MEMORANDUM

Date: Dec 10, 2014
Project: 97 State Street, Portland, ME
From: David Tetreault
Subject: Response to Building Dept. Review Comments

Project:
97 State Street Porch

7 | STRUCTURAL SECTION
1" = 1'-0"

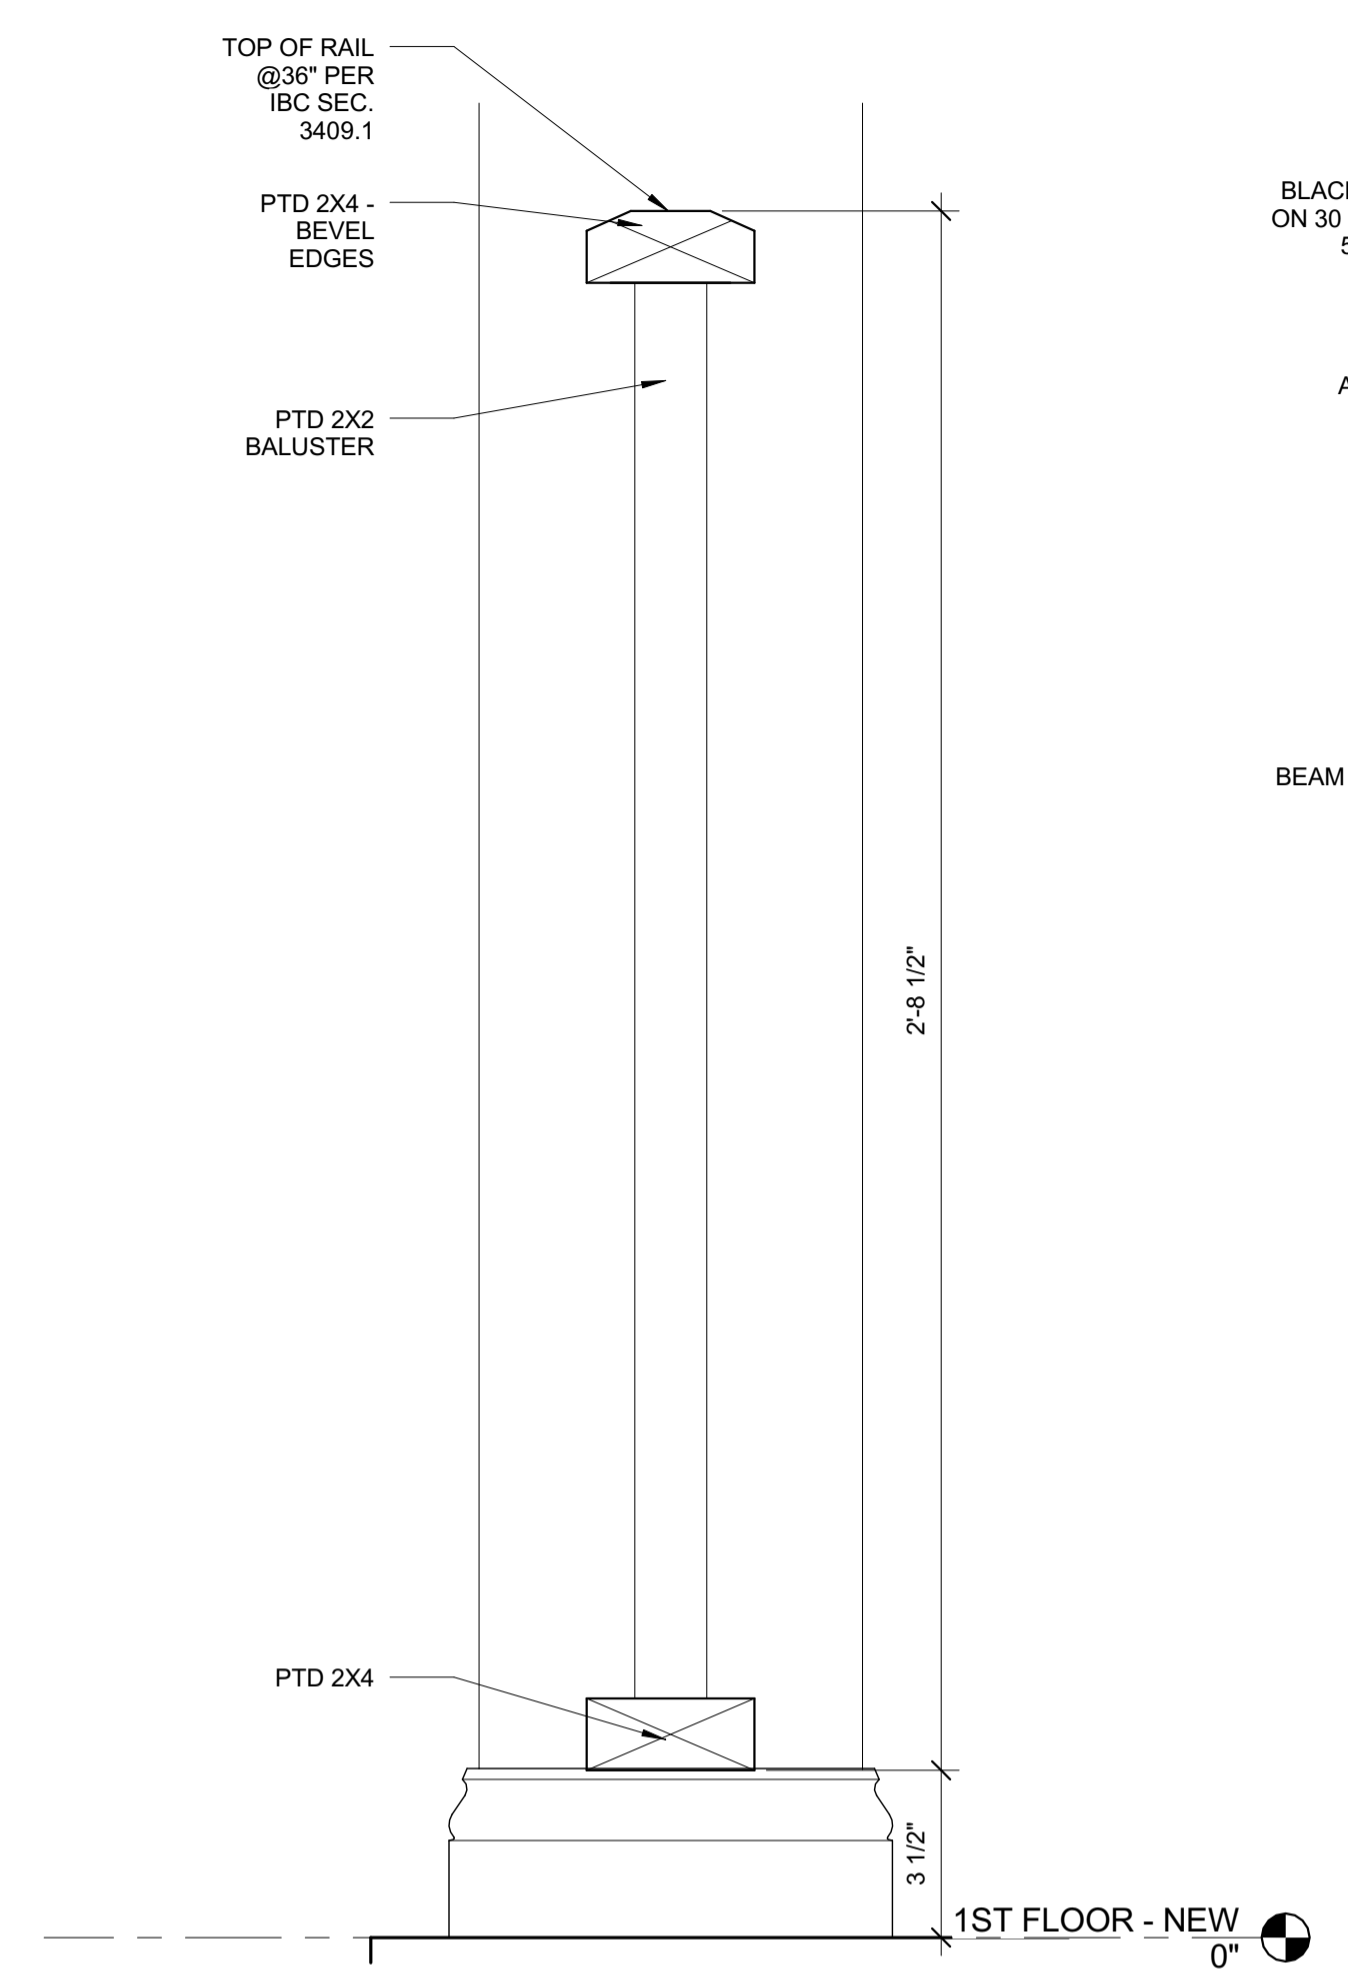
Attached are calculations that I prepared for support of the exterior porch floor beam as shown on Structural Section 7/A2.01. Following are the design criteria used:

Floor Dead Load	12 PSF
Floor Live Load	100 PSF
Fastener Allowable Shear	940 Pounds
